AIMOC WIM

03 - Static inbound + static outbound

CONFIDENTIAL - CONCEPT

PLAN · TWO STATIC STATIONS

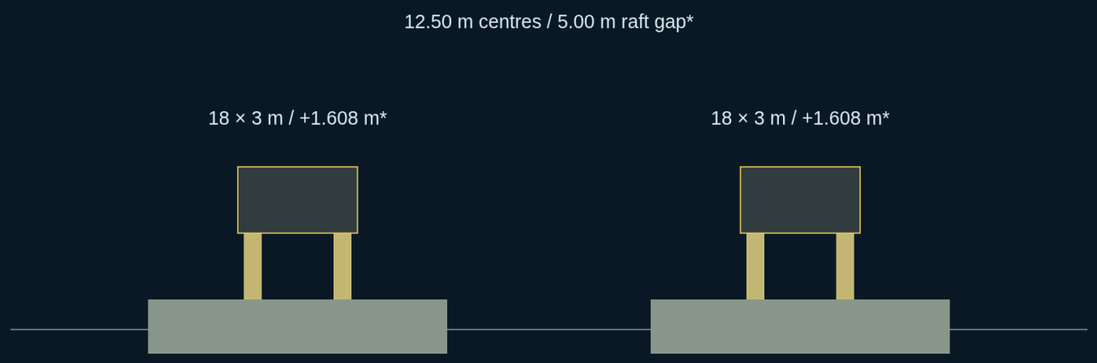
*Coordination: two 28 × 7.5 m rafts; two 52.32 m footprints; loop/holding excluded.

Civil assumptions: 28 x 7.5 x 0.35 m raft; 100 mm pedestal; 100 mm mount; 308 mm module. OEM reinforcement, concrete grade, anchors and bearing design are not supplied. Verify settlement, flooding, drainage, corrosion and adjacent-foundation interaction before construction.

PDF does not provide foundation/ramp drawings, reinforcement, concrete grade, bearing or anchor details. Foundation drawing is supplied after PO.

The simulated 28 × 7.5 × 0.35 m raft, levels and ramps are coordination assumptions. Check CPT/SPT, settlement, adjacent static interaction, drainage/flooding and excavation limits.

The 3 m nominal platform differs from the 3.2 m overall drawing width. A 3.2 m truck is on engineering hold until tyre positions, guard-rail clearance and swept envelope are approved.
